Title: A/C Condensers for LT and RH Part Number Update

Applies To: LT and RH built before Nov 20th, 2017

This document will show the user the difference between original production and new A/C Condensers for LT and RH vehicles.

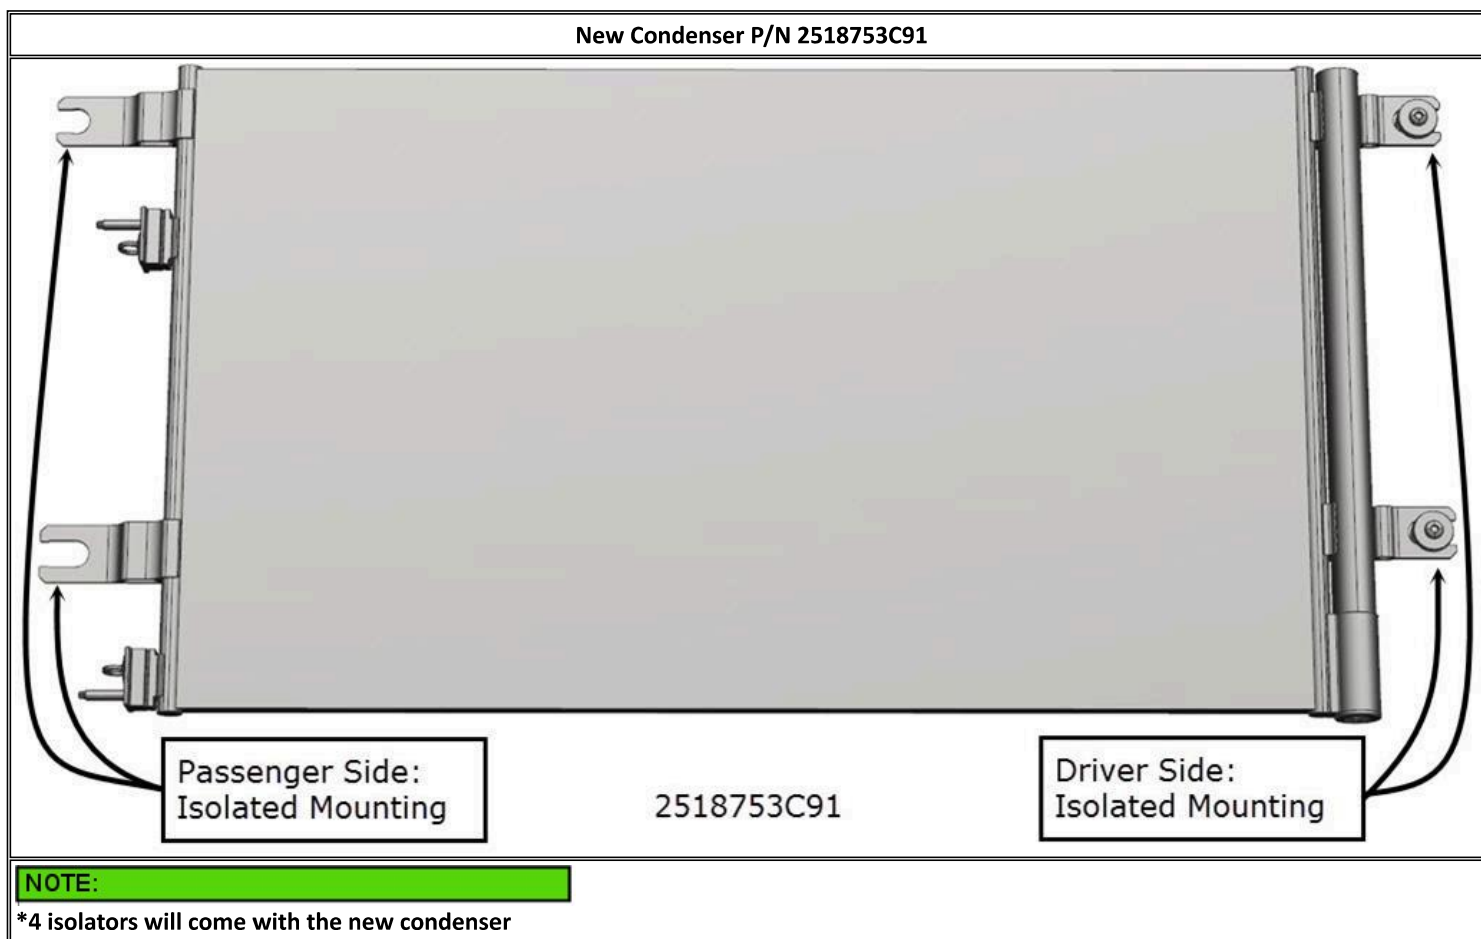
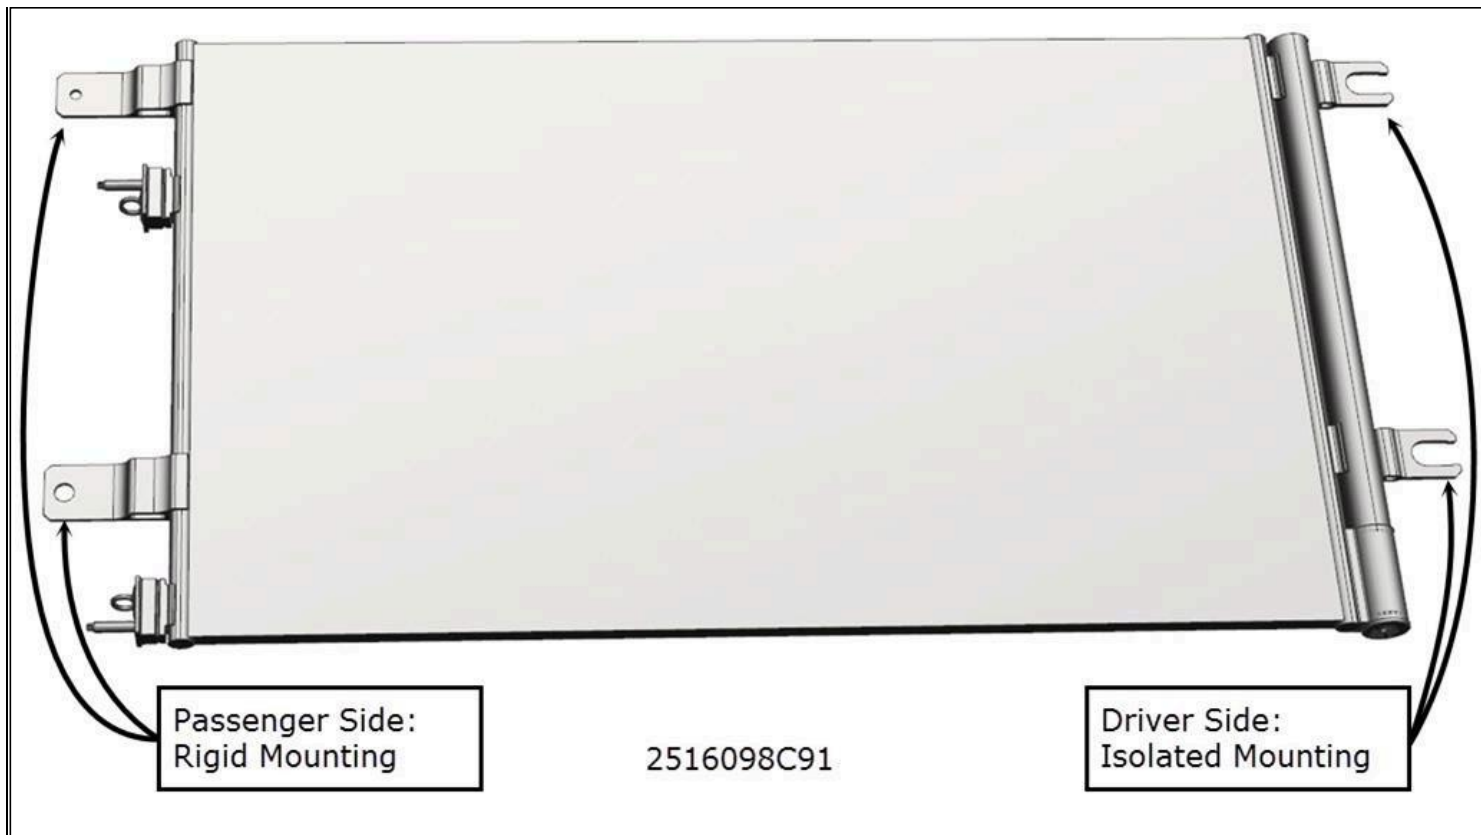
Condenser P/N 2516098C91 has been replaced with P/N 2518753C91, see images below:

Old Condenser P/N 2516098C91

Identify Microchannels on Condenser

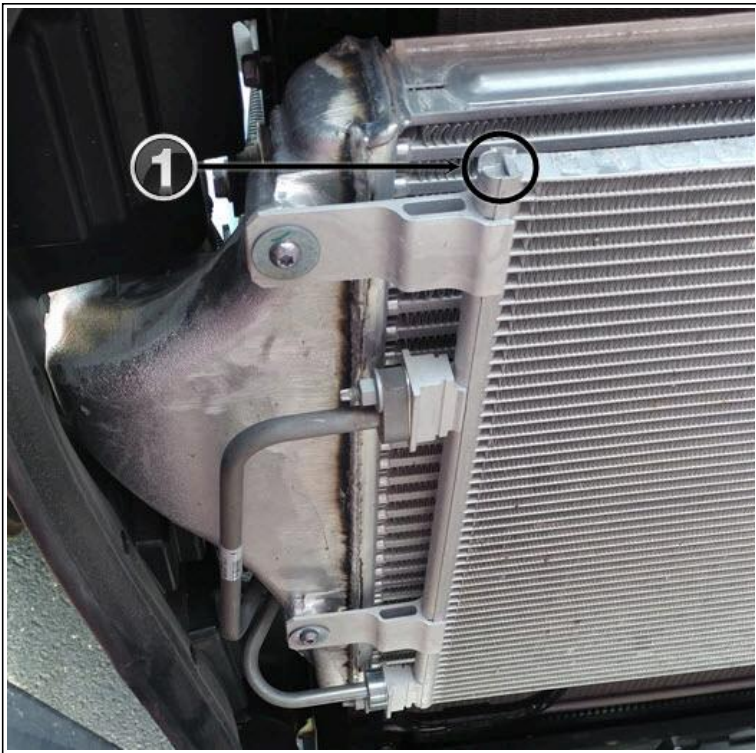
The New Condenser can also be identified by the number of microchannels in the tubes

1. Microchannels can be seen on the top or bottom tube of the condenser
 - o The top and bottom tube are not functional

Original Condenser - 18 Microchannels

- A small number of production vehicles had 4 isolators with the 18 Microchannel design (Built between 10/17/2017 and 11/08/2017)
- 4 Isolators with 18 Microchannels was never available as a service part

New Condenser 2518753C91 - 8 Microchannels

The New Condenser 2518753C91 is the only available service part
